CONSTRUCTION SUMMARY - PARTIAL ONLY

Northglen (E) - Bowmanville Estates Inc.

LOT NUMBER	PHASE	HOUSE TYPE	REG. PLAN #	CLOSING DATE
21	ppleview	Coburg (37-3) Elev A	40M-2612	22-Apr-21

This Document is Extremely Time Sensitive - Printed 12 May 21 at 11:14

MAIN FLOOR - ELEV A

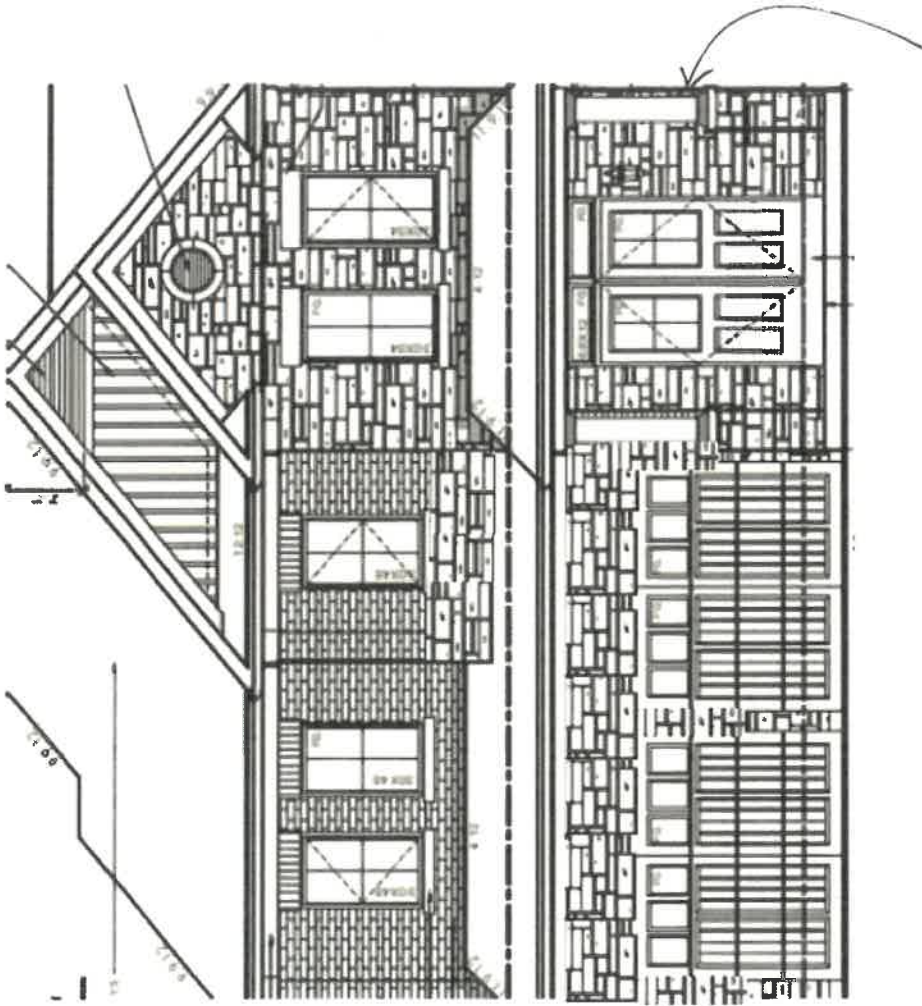
* ADD PANTRY —
12" DEEP
24" WIDTH
DOUBLE DOOR

* REMOVE -
STOVE -
UPPER

*REV. 25/11/20
AOD ELECTRICAL
RECEPTACLE

*THIS FLOOR
PLAN ONLY TO
HIGHLIGHT THESE
CHANGES*

REVISION
25/11/20
CHANGE
TO
30"

DRAWING FOR STONE ONLY

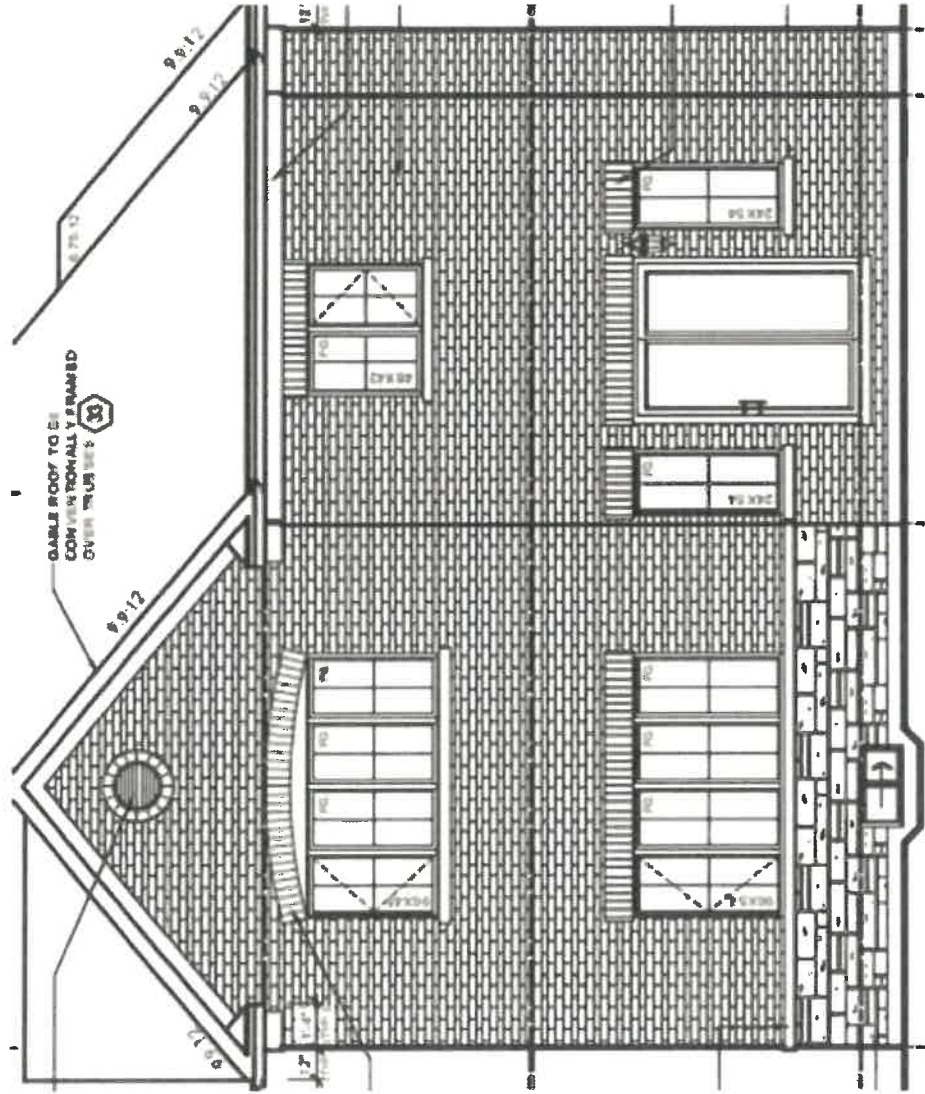
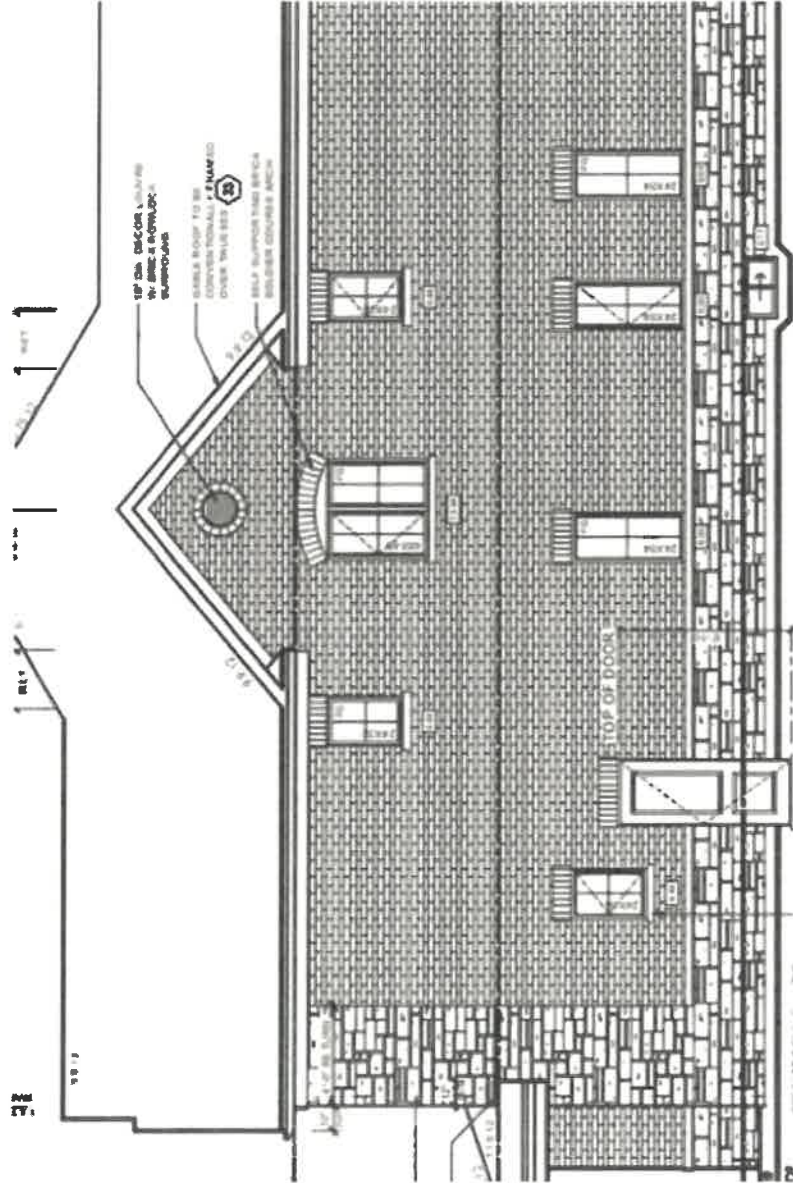
2,041	1 - REVISION TO STAGE 1: ADD STONE TO FRONT OF HOUSE, SIDES AND REAR AS NOTED ON ATTACHED DRAWINGS STONE SELECTION IS AS PER PACKAGE #3 Note:
12May21	9200

COLUMNS
LIKE ELEV. B.
DOUBLE SQ.
COLUMNS

Item	Description	Qty.
1 - R00001	REVISION TO STAGE 1:	1
3	ADD STONE TO FRONT OF HOUSE, SIDES AND REAR AS NOTED ON ATTACHED DRAWINGS	
STONE SELECTION IS AS PER PACKAGE #3
